6 B0300030

SB, 340, 345, 346, 350, 353, Winter cover, 2003-03

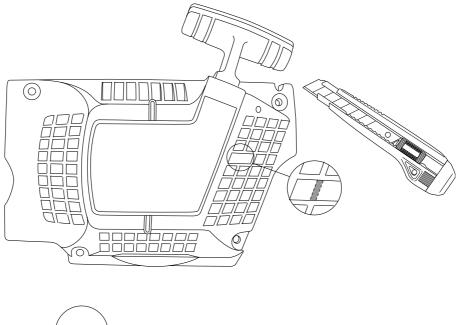
Due to a modification to the starter, see bulletin B0300006, the winter cover must also be modified. This also requires a minor adjustment to the starter.

If the winter cover is a loose fit, file off the lugs as shown in the diagram below.

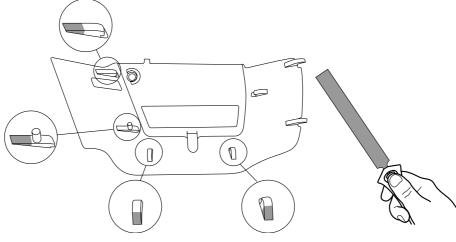
In order to block the air injection nozzle one of the fins on the starter must be cut off as shown in the diagram below.
